project title
 Plot at Cae Glas, Lon Cae Glas, Llanbedr D.C.

APPLICATION NO: 16/2018/0659/ PR

PROPOSAL: Details of appearance, landscaping, layout and scale of 1 dwelling submitted in accordance with condition number 1 of outline permission code 16/2017/1074 (reserved matters application); parking and turning scheme and details of foul and surface water drainage submitted in accordance with condition 7 and 11 of outline permission code 16/2017/1074

LOCATION: Land at (Part garden of) Cae Glas Lon Cae Glas Llanbedr Dyffryn Clwyd Ruthin

PROPOSED SITE PLAN

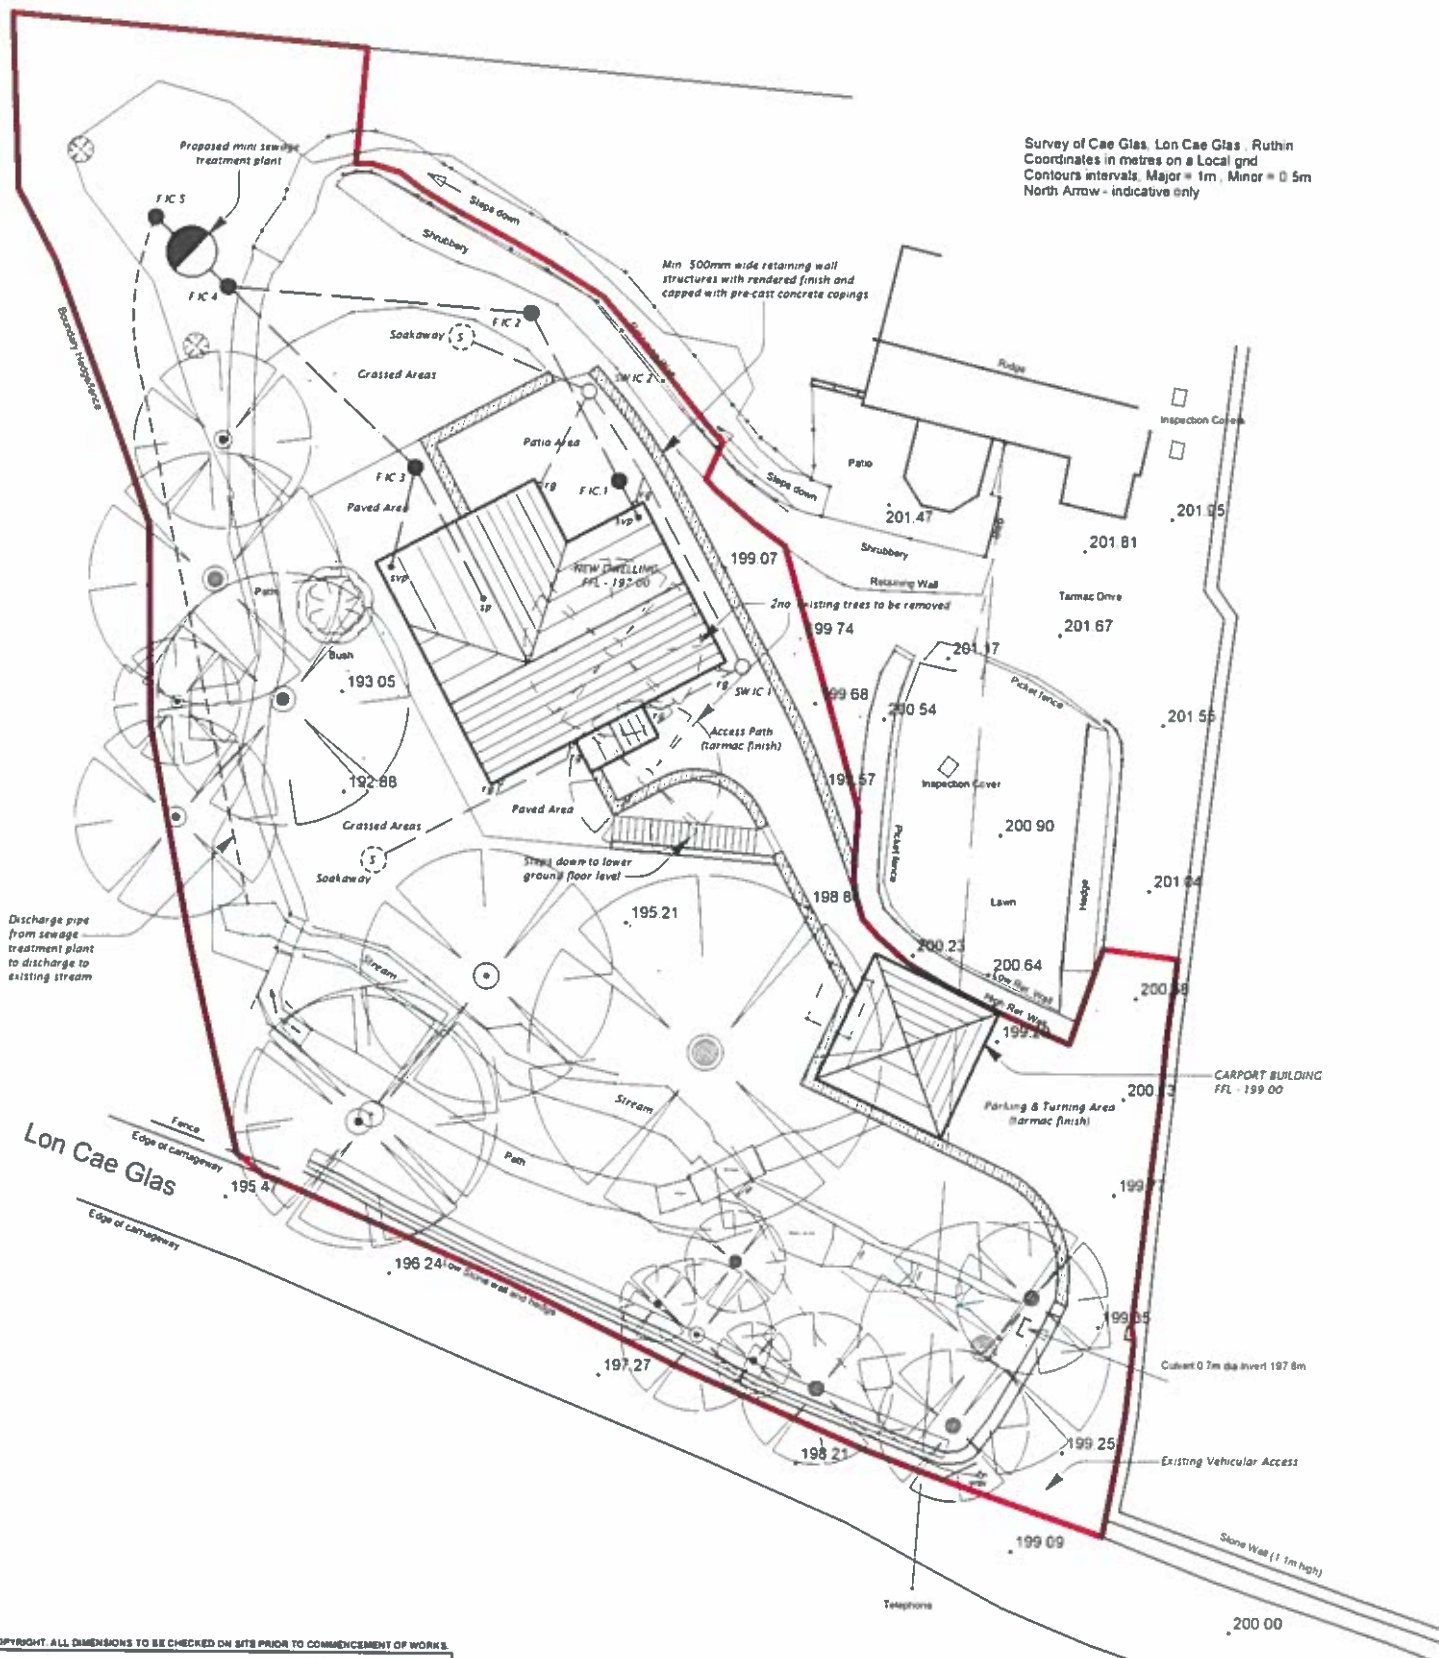
Object to the parking and turning area / condition 7 relates to all vehicles and not just cars / Application does not make provision for the parking and turning of large construction vehicles or delivery vehicles (e.g. tankers for the delivery of oil and large vehicles for the removal of waste) / condition 7 has been complied with / Proposal would be harmful to highway safety / Turning circle now proposed appears to be smaller than the turning area shown on the outline plans /Boundary fence between existing dwelling and neighbour to east has already been damaged by inappropriately sized vehicles trying to gain access to the existing dwelling / Lon Cae Glas is a single track lane which is described by the Local Authority as 'Not Suitable for Motor Vehicles' / Council's duty to ensure decision does not contravene public safety and does not result in damage to private property /Highway Officers have not evidenced why they consider condition 7 has been met.

The Community Council and private individuals have not raised comments with respect to the landscaping. The AONB Advisory Committee have commented on the proposed hard landscaping and consider the retaining walls should be stone facing to match the existing wall along the road frontage.

Notwithstanding the comments of the AONB Advisory Committee, Officers consider the proposed finish to the retaining wall would be acceptable given that the site is located within the development boundary and that a number of dwellings in the

Whilst the parking and turning area currently proposed differs from the indicative arrangements shown on the proposed site plan at outline stage, the provision of a double carport with further parking space to the front, and turning space within the existing driveway is considered acceptable and would meet the Council's Parking Requirements in New Developments SPG, and ensure cars exiting the site can do so in forward gear rather than reversing on to the highway. Accordingly, Highway Officers have raised no objection to the proposed parking and turning area.

Highways Officers are satisfied proposed parking and turning arrangements are acceptable, and have raised no objection to the proposed layout, or to the discharge of condition 7.

PROPOSED ELEVATIONS

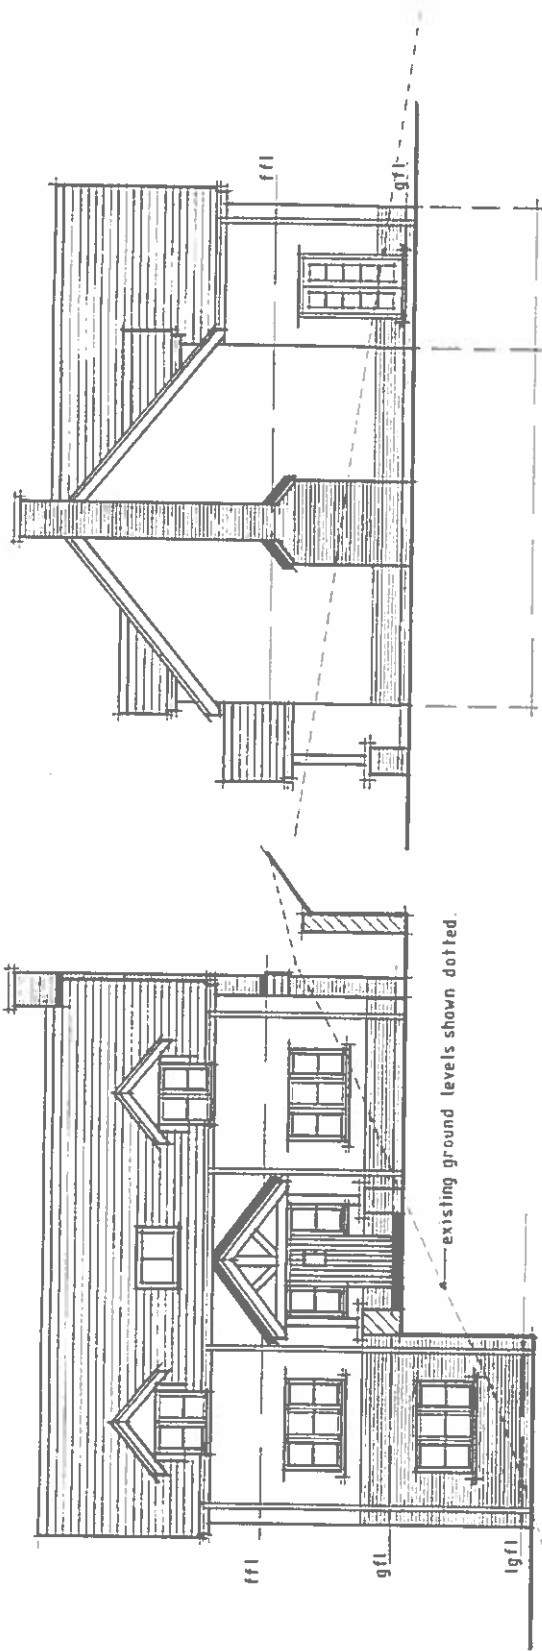
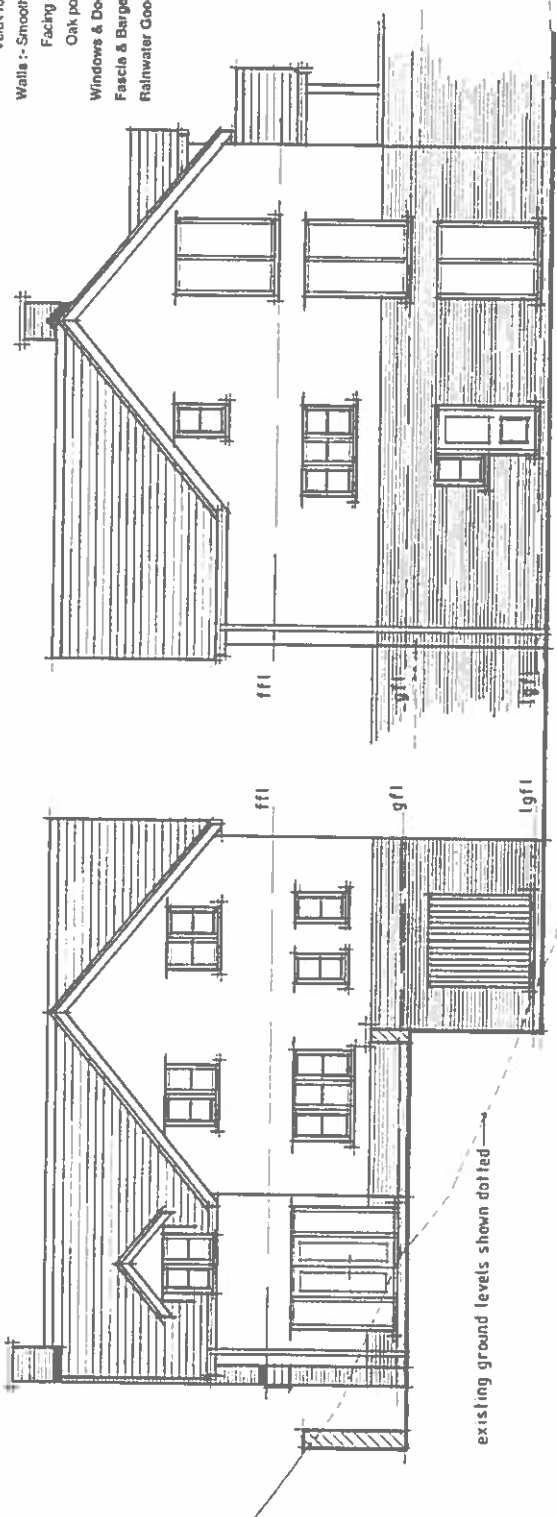
“The Joint Committee has no objection to the overall design and landscaping but would recommend that the retaining walls and proposed brick faced plinth and lower ground floor walls should be faced in traditionally finished natural local stone to match the existing frontage walls. In addition, the roof should be covered in natural blue/grey slate and not fibre cement tiles as specified.”

The Community Council and private individuals have not commented with respect to the appearance of the proposed dwelling. The AONB Advisory Committee has no objection to the overall design and landscaping but recommend that the retaining walls and proposed brick faced plinth and lower ground floor walls should be faced in traditionally finished natural local stone to match the existing frontage walls, and the roof should be covered in natural blue/grey slate and not fibre cement tiles as specified.

Having regard to the design of the dwelling proposed in relation to surrounding dwellings in the locality, Officers do not consider it would be reasonable to refuse the application on grounds of the proposed materials. The details proposed in relation to the dwellings are considered acceptable and in keeping with surrounding development.

It is therefore considered that the appearance of the development would be respectful of the location.

DRAINAGE PLAN

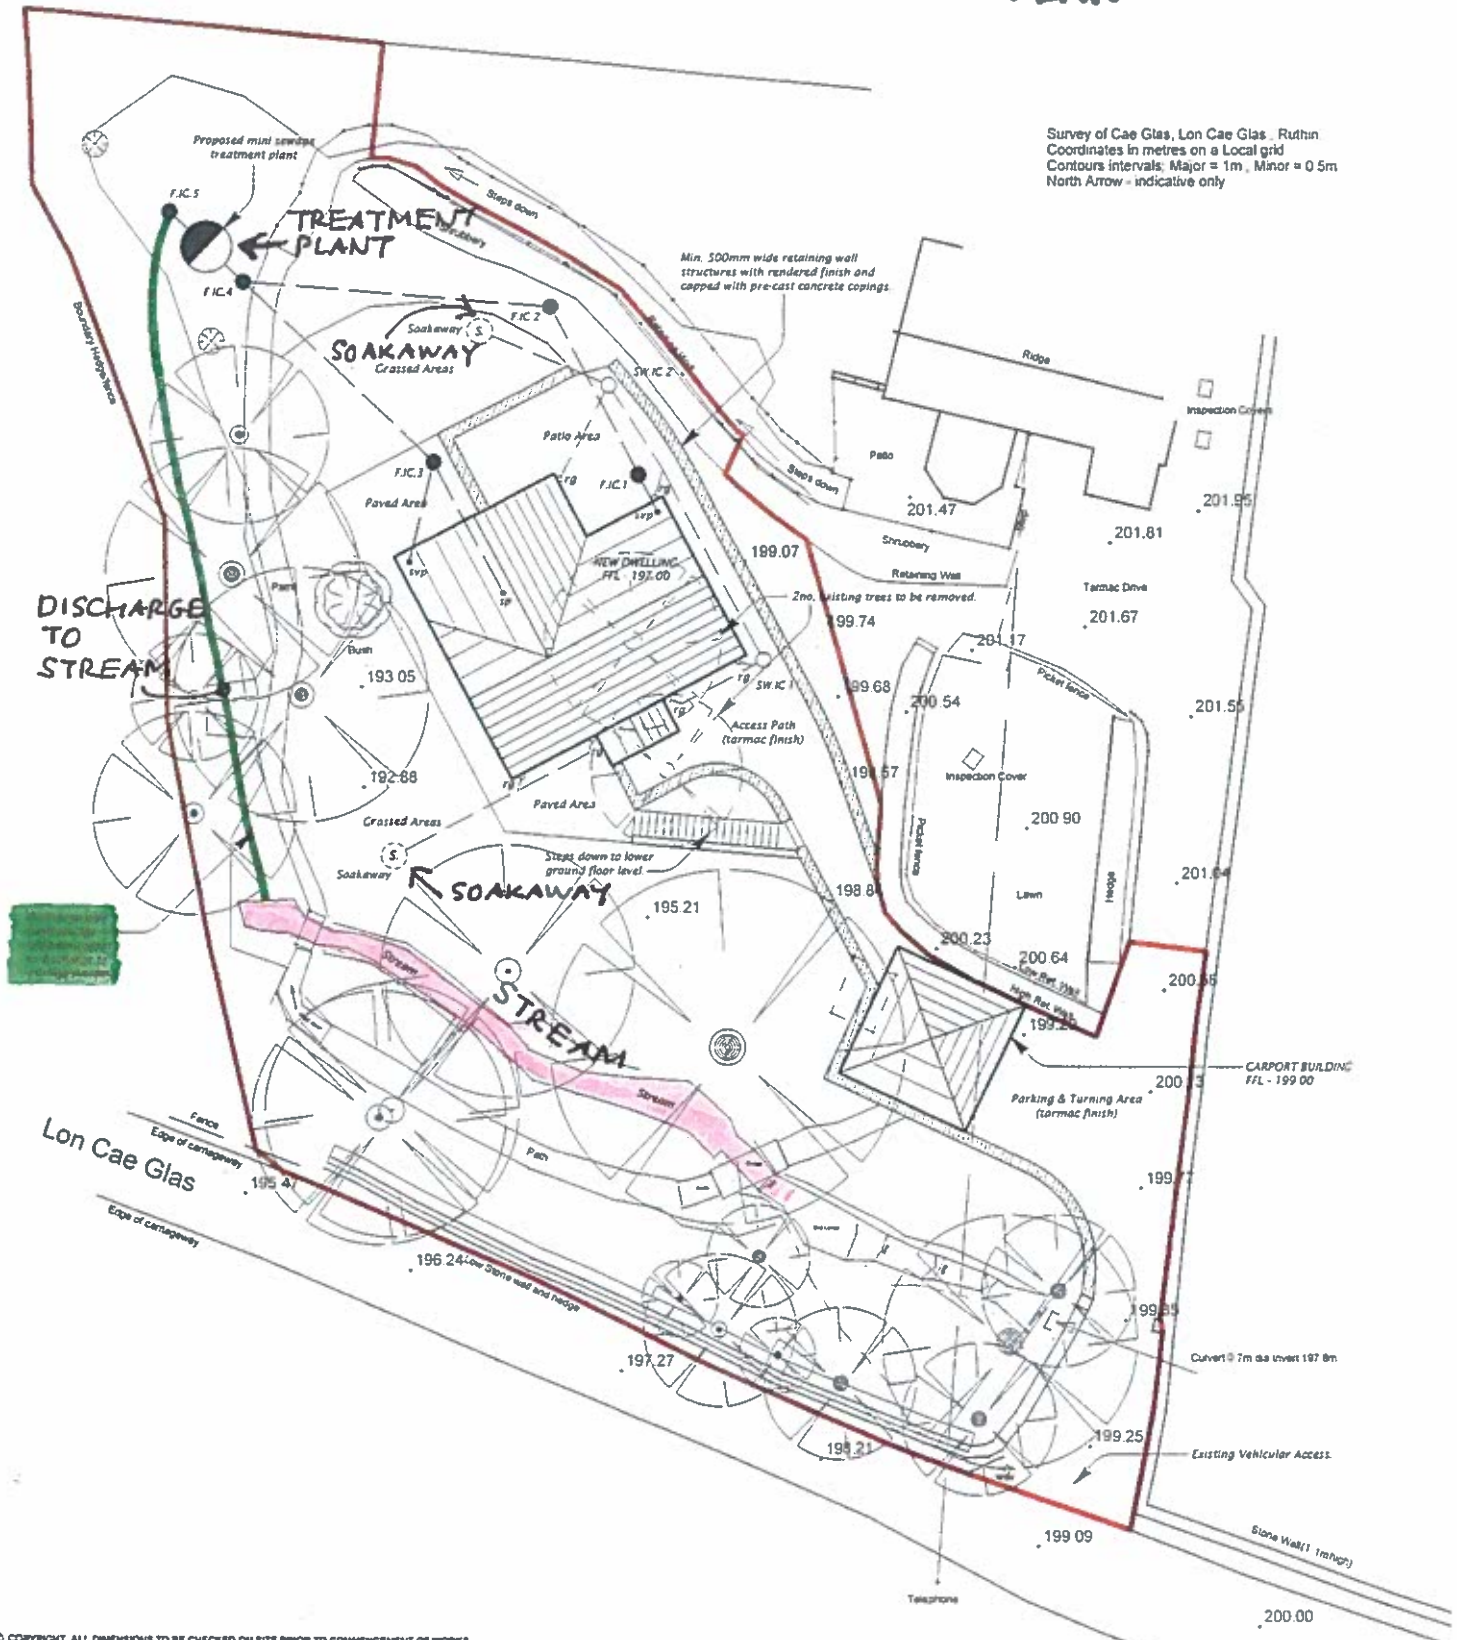
1. Concerns regarding the waste discharge which may be contaminated.
2. Highway safety issues regarding the vehicle access which should be addressed.”

Concern that as site is on sloping ground, the package treatment plant would be at a higher ground level than the house to the west / section plans are required to demonstrate the proposed drainage system is workable/ concern regarding the validity of the percolation tests bearing in mind that they have been carried out during one of the driest periods for many years / the water table is extremely high with water seeping through the bank / concern in periods of high rainfall ground seepage would mean neighbouring properties would become contaminated with waste water.

The foul drainage will discharge to a mini sewage treatment plant to the location shown on site.

The cover level of the tank will be set at approximately 193.50.

The outlet from the sewage treatment plant will discharge via a gravity piped system to the watercourse passing through the development site.

The outlet into the stream will be at a level of approximately 191.50 – so a gravity piped system from the outlet on the tank to the outlet to the stream will be achievable on this site.

Details of the proposed sewage treatment plant were submitted with the application, and additional information has been provided which confirms the outlet from the sewage treatment plant will discharge via a gravity piped system to the watercourse passing through the development site and that the water from the sewage treatment plant will be clean treated water and acceptable for discharge into the existing water course, and therefore there is no risk of contamination from the sewage treatment plant to any neighbouring properties.
